CITY PLAN COMMISSION**THURSDAY, MARCH 21, 2024****FILE NUMBER:** S234-066**SENIOR PLANNER:** Sharmila Shrestha**LOCATION:** Dowdy Ferry Road, north of Lyndon B Johnson Freeway/ Interstate Highway No. 20**DATE FILED:** February 22, 2024**ZONING:** CS**CITY COUNCIL DISTRICT:** 8**SIZE OF REQUEST:** 2.0631-acres**APPLICANT/OWNER:** 635-Dowdy Venture**REQUEST:** An application to create one 2.0631-acre lot from a tract of land in City Block 8524 on property located on Dowdy Ferry Road, north of Lyndon B Johnson Freeway/ Interstate Highway No. 20.**SUBDIVISION HISTORY:**

PROJECT:
Preliminary Plat
LOT 1, BLOCK 8524
CITY BLOCK NO. 8524
BEING A 2.0631 ACRE TRACT OF LAND
JOHN R. FOWDEN SURVEY ABSTRACT NO. 476
CITY OF DALLAS, DALLAS COUNTY, TEXAS
CITY PLAN FILE NO. 5234-066

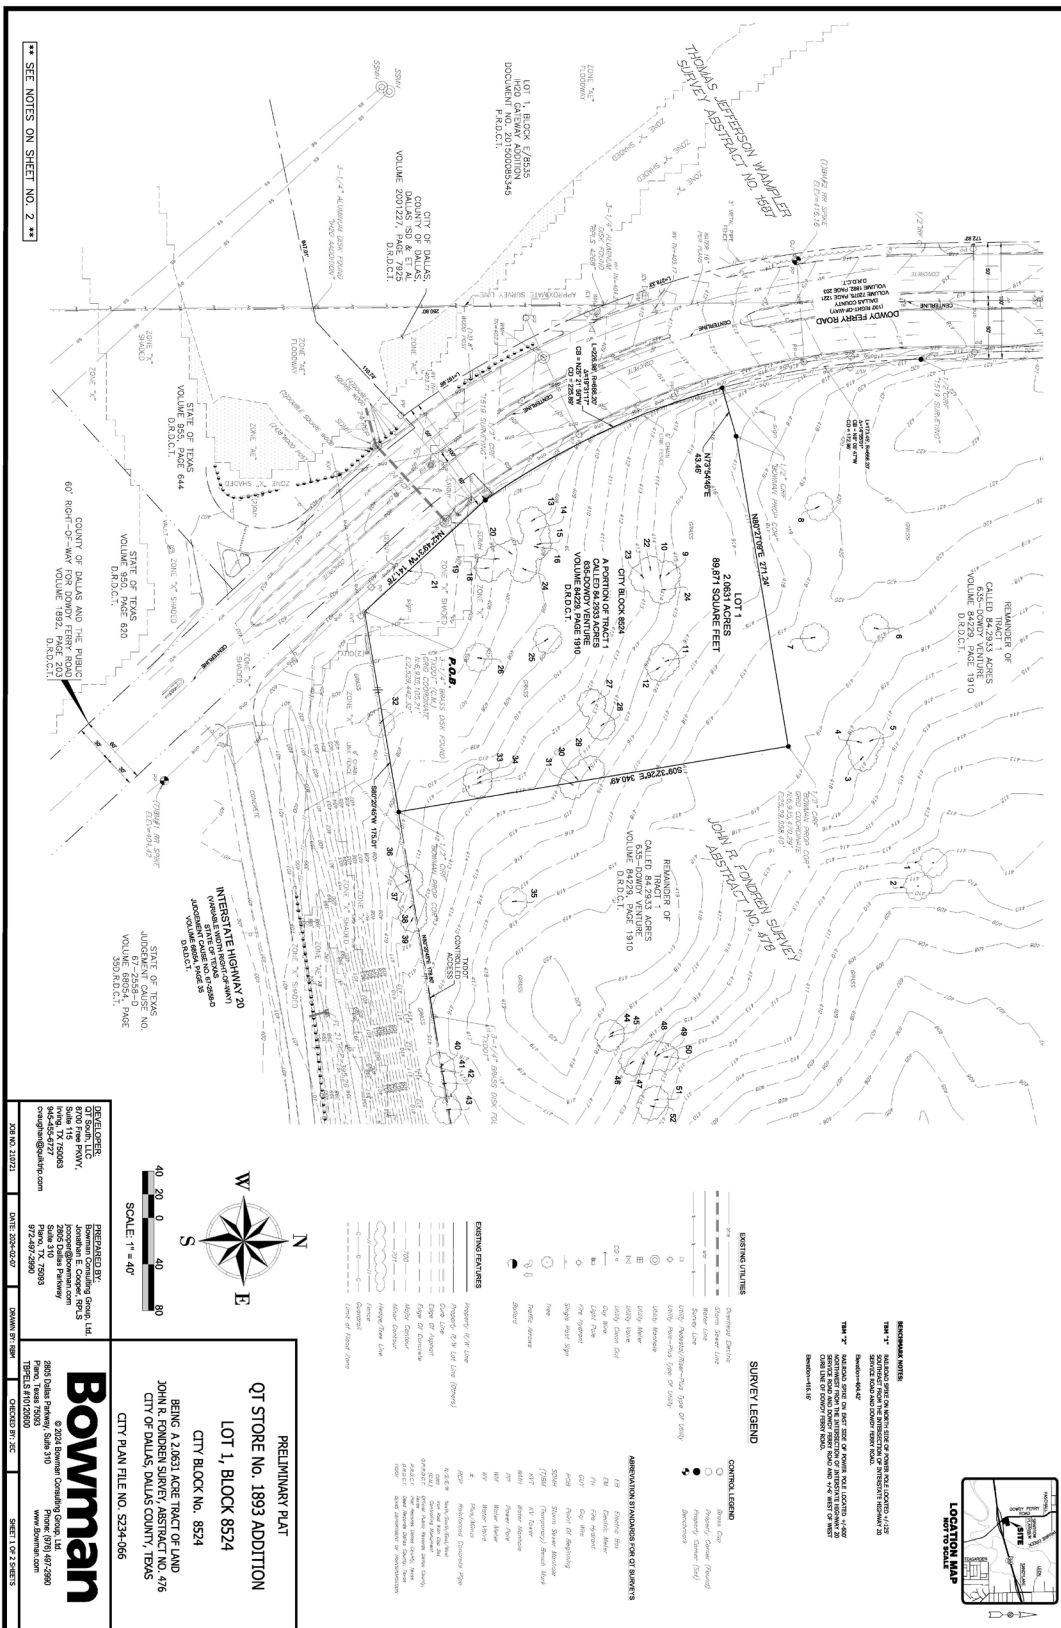
15. On the final plat, dedicate 50 feet of right-of-way (via fee simple) from the established center line of Dowdy Ferry Road. *Section 51A 8.602(c)*
16. TxDOT approval may be required for any driveway modification or new access point(s).
17. Must coordinate with Transportation Department for any traffic signal requirements that are deemed necessary for improving pedestrian accessibility and safety related to site development. (Contact Srinivasa Veeramallu with Traffic Signals) *Section 51A-8.606, 51A-8.608*

18. On the final plat, determine the 100-year water surface elevation across this addition.
19. On the final plat, dedicate floodway easement, floodway management area or floodway easement (within common area), with the appropriate easement

20. On the final plat, include additional paragraph in Owner's Certificate (pertaining to the floodplain). 51A 8.611(d); DWU Floodplain Management; Drainage Design Manual Addendum V
21. On the final plat, specify minimum fill and minimum finished floor elevations. *Section 51A-8.611(d), Trinity Watershed Management.*
22. On the final plat, show the natural channel set back from the crest of the natural channel. *Section 51A-8.611(d), Trinity Watershed Management.*
23. Prior to submission of the final plat, set floodway monument markers and provide documentation that the monuments have been set. *Section 51A-8.617(d)(1), (2), (3), and (4)*
24. Provide information regarding Fill Permit or Floodplain Alteration Permit if such permit is applied for.

25. Prior to final plat, submit a completed final plat checklist and all supporting documents.
26. On the final plat, show the correct recording information for the subject property.
27. On the final plat, show recording information on all existing easements within 150 feet of the property.
28. On the final plat, show all additions or tracts of land within 150 feet of the property with recording information.

29. Additional design information is required for assessment. Site plan must be submitted showing proposed development, building finished floor elevation, development, existing mains – including downstream manhole, and proposed water and wastewater service locations. Submit water/wastewater engineering plans to 320 E. Jefferson Blvd., Room 200, Attention: Water and Wastewater Engineering.
30. Engineer must furnish plans for water and sanitary sewer. Developer must furnish a contract for water and sanitary sewer. Sections 49-60(g)(1) and (2) and 49-62(b), (c), and (f).
31. Wastewater main improvements may be required by Private Development Contract. Submit water/wastewater Engineering Plans to 320 E. Jefferson Blvd., Room 200, Attention: Water and Wastewater Engineering.

32. On the final plat, change "Interstate Highway 20" to "Lyndon B Johnson Freeway/ Interstate Highway No. 20".
33. On the final plat, identify the property as Lot 1 in City Block A/8524.
